Review of the kinematic interpretation of the tectonic structures in northern Switzerland

Expertenbericht

im Rahmen der Beurteilung des Vorschlags von mindestens zwei geologischen Standortgebieten pro Lagertyp, Etappe 2, Sachplan geologische Tiefenlager

**Review of the kinematic interpretation of the
tectonic structures in northern Switzerland**

Figure 2—2 : Comparison of the quality of reprocessed seismic lines of the 1982 (a) / 1991 (b) surveys with the new acquired (2011/12) seismic lines. TWT = Two-way travel Time. Modified from NAB 13-10, Fig. 2-3. For location see Beilage 2-1, NAB 13-10.

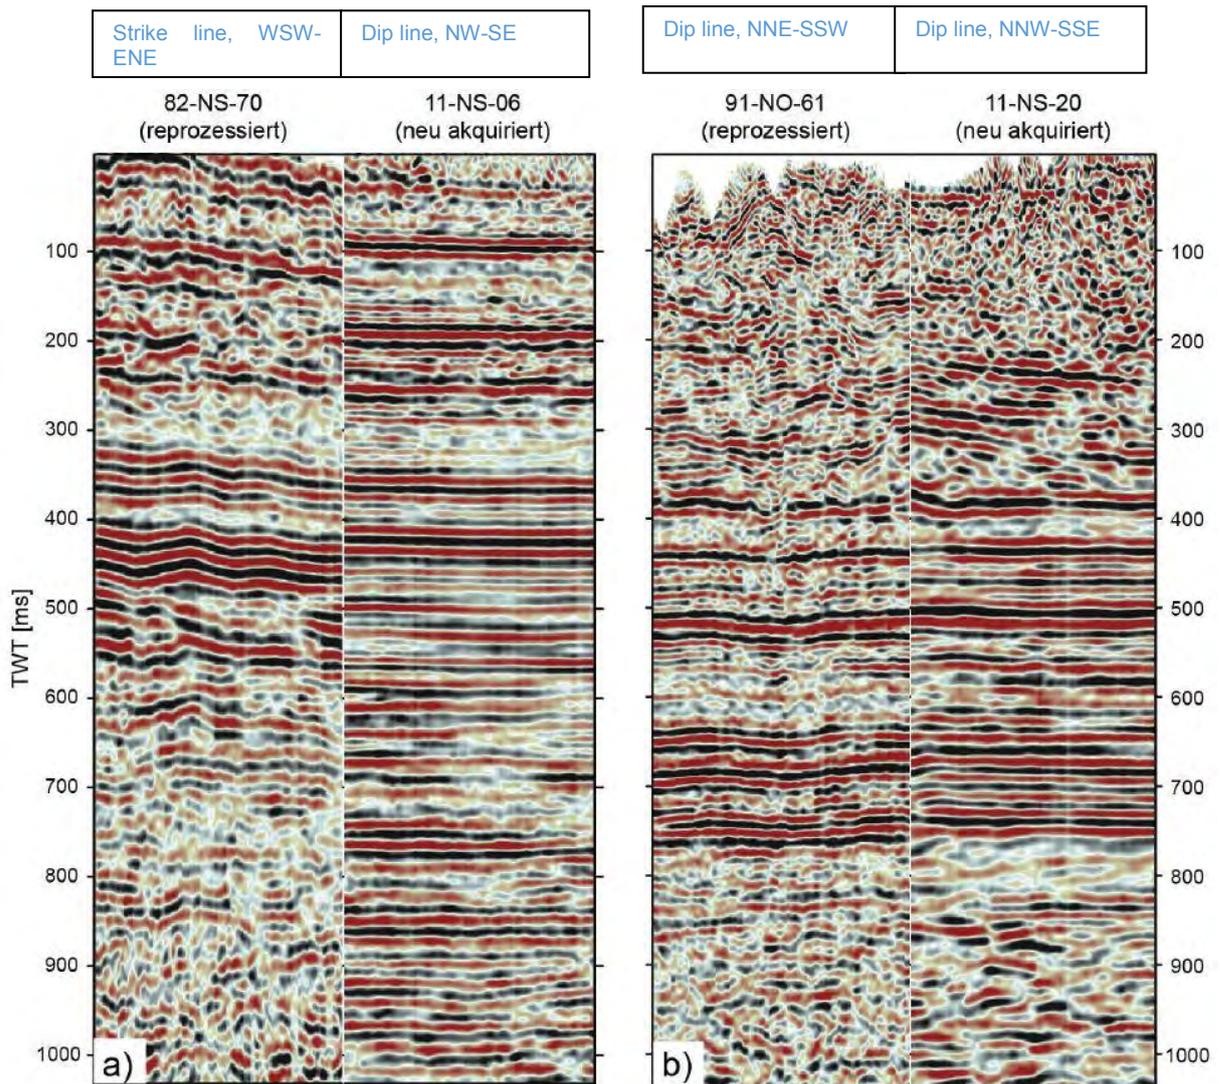
In Figure 2—2, the horizontal scale is missing (it is not shown on the original figure in the NAB 13-10 report) and we assume that the horizontal scale is the same for the fourth lines. Nagra compares the seismic data quality of two seismic lines, which do not have the same direction. Directions have been added for the assessment on top of the Figure: a) strike line WSW-ENE versus dip line, NW-SE and b) two dip lines with a different direction (NNE-SSW, NNW-SSE). Although this is not an optimal way to compare the seismic quality of the lines, we can see an improvement of the seismic image from the old to the new acquired seismic surveys. Supposedly the line in the middle of the Figure 2—2 a and b corresponds to the intersection line between the two lines.
